Planning Application

In respect of an Amendment to a Previously Permitted Industrial Scheme (Permitted under SD19A/0407, as amended by SD21A/0200) at a Site Known as 'Site C', College Lane, Greenogue, Rathcoole, Co. Dublin

RE: AMENDMENT TO A PREVIOUSLY APPROVED WAREHOUSE DEVELOPMENT COMPRISING AN OVERALL INCREASE IN THE COMMERCIAL FLOOR AREA FROM THE PERMITTED 27,683 SQ M TO 30,017 SQ M AT A SITE KNOWN AS SITE C, COLLEGE LANE, GREENOGUE, RATHCOOLE, CO. DUBLIN

Figure 5.1: Permitted (SD21A/0200) and Proposed Ground Floor Plans

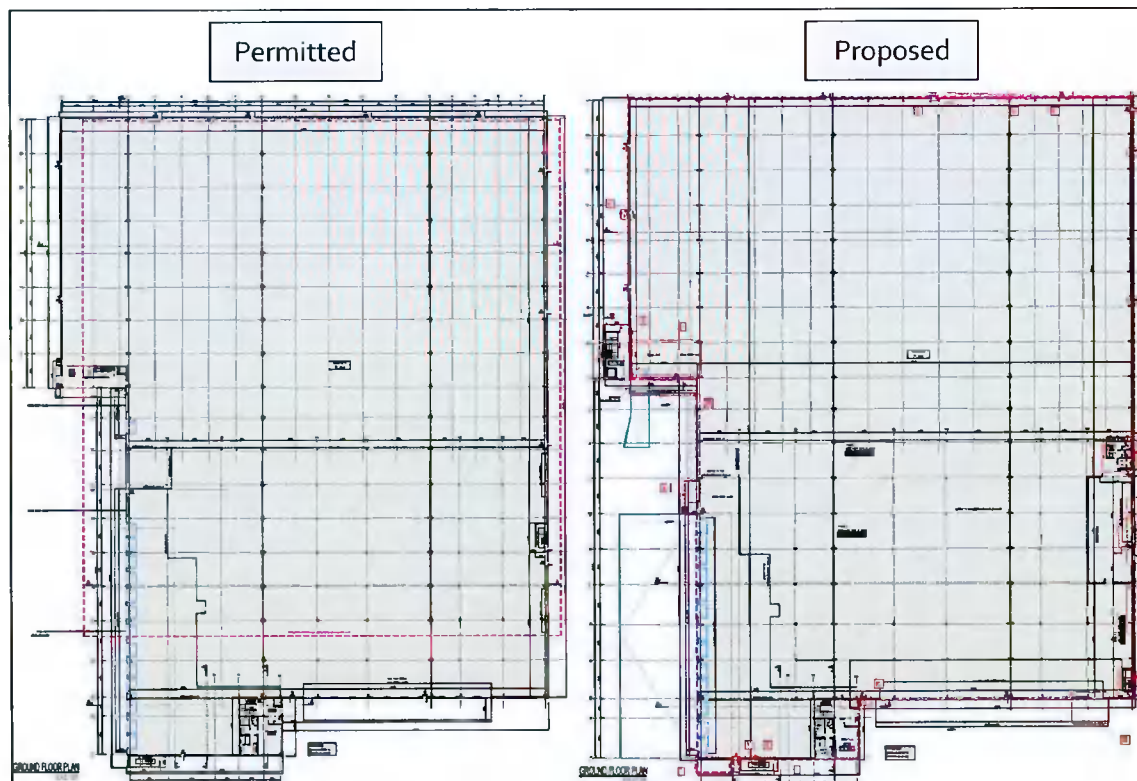
At ground floor level, the relocation of the building's main entrance stair core at the western elevation is proposed along with internal modifications to include the insertion of a warehouse toilet block and the repositioning of stair cores. Elevational changes are also proposed at ground floor level including the repositioning of 2 No. level entry doors and 1 No. dock leveller and associated canopy, the removal of 2 No. M&E rooms and the repositioning of fire escape doors throughout the scheme. Modifications to the position of the van loading entry doors and associated canopy along the southern and eastern elevations are also proposed.

Figure 5.2: Permitted (SD21A/0200) and Proposed First Floor Plans

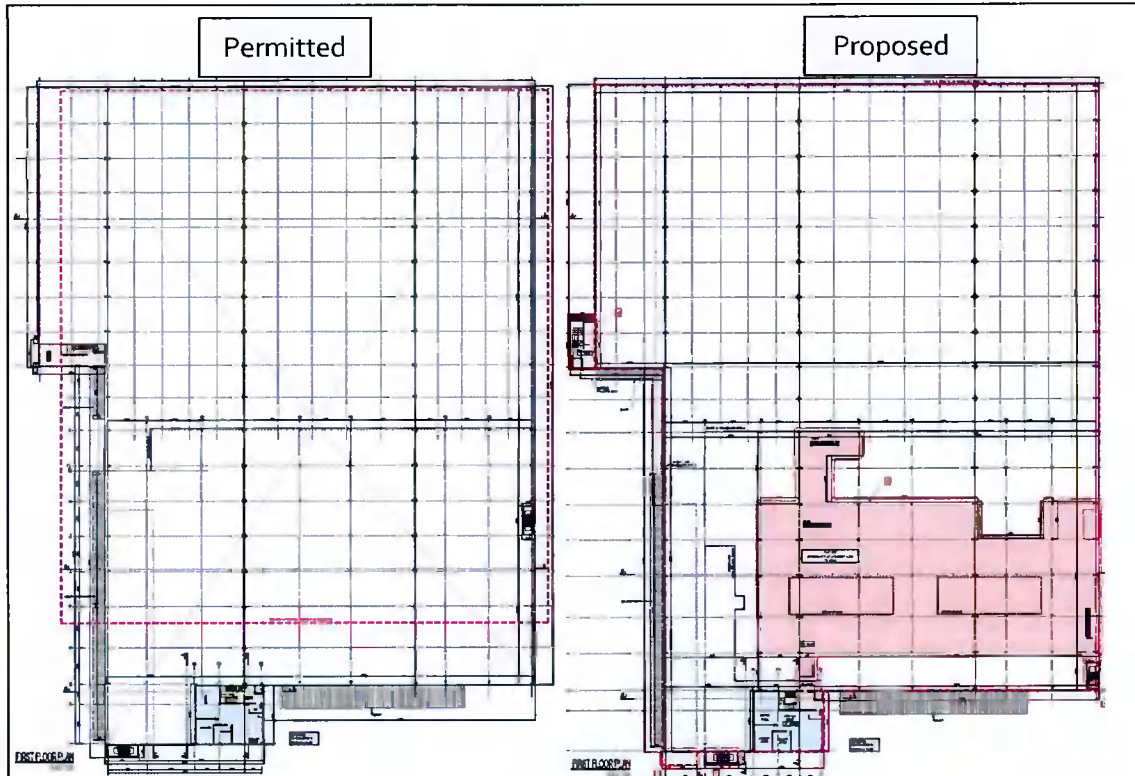
New warehouse mezzanines are proposed at first floor level, measuring 2,570 sq m, to accommodate plant and machinery. A 26 sq m reduction in staff facilities is also proposed at this level.

Figure 5.3: Permitted (SD21A/0200) and Proposed Second Floor Plans

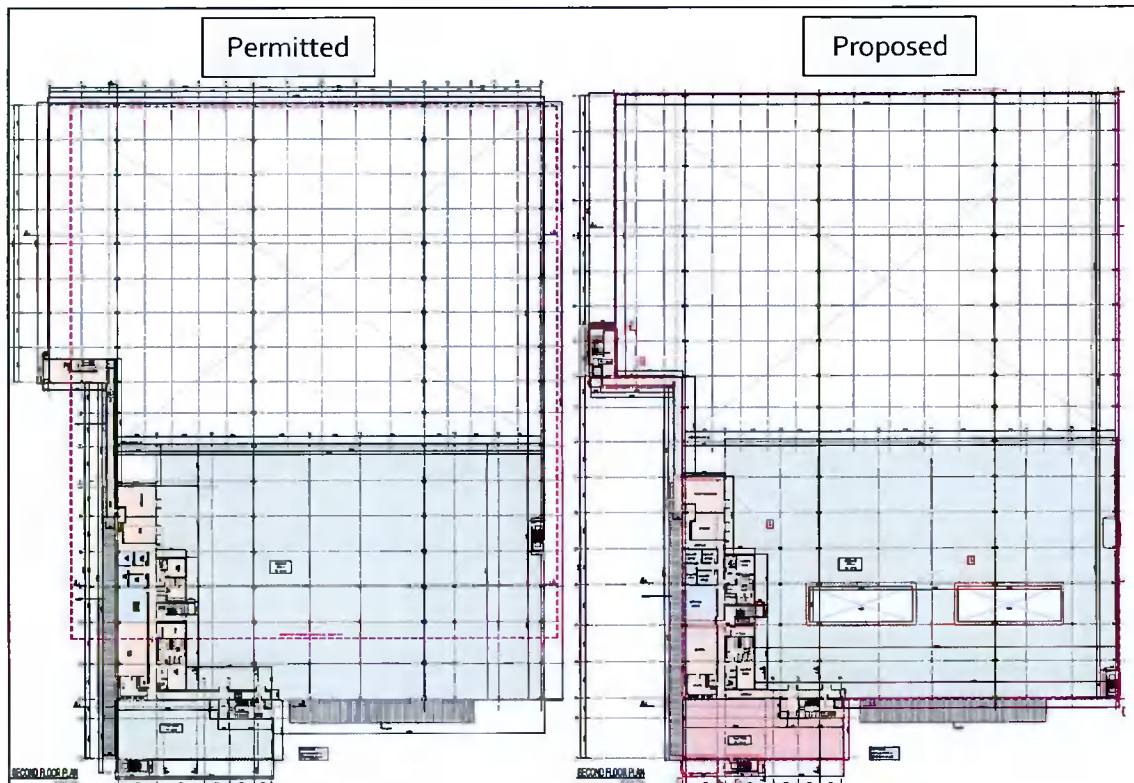
At second floor level, the provision of 2 No. opes in the permitted mezzanine is proposed resulting in a 363 sq m reduction in warehouse mezzanines from the previous amendment permission. Slight adjustments to the ancillary office/staff facilities block to facilitate structural alignment and accommodate the relocation of the main entrance stair core has resulted in a 19 sq m increase in staff facilities along with a 13 sq m increase in office space at this level.

Figure 5.4: Permitted (SD21A/0200) and Proposed Third Floor Plans

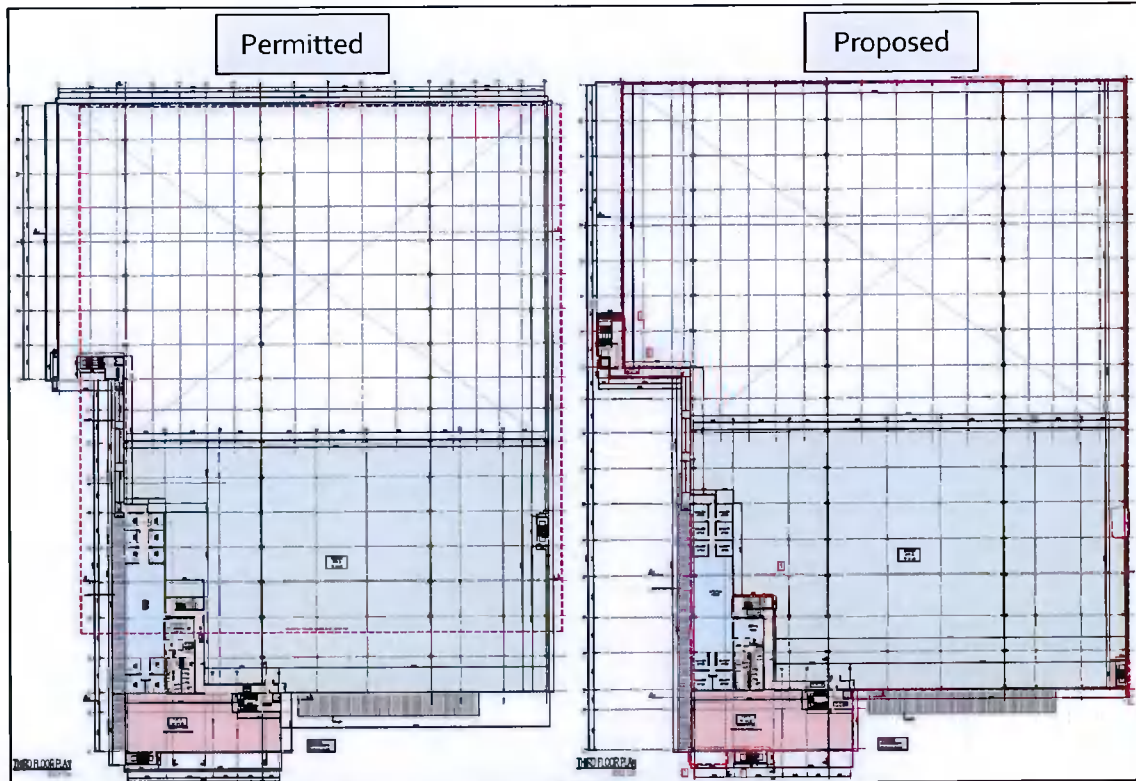
The repositioning of the stair core and minor structural alignments has resulted in a 9 sq m increase in warehouse mezzanines, a 42 sq m increase in staff facilities and a 5 sq m increase in office space at third floor level.
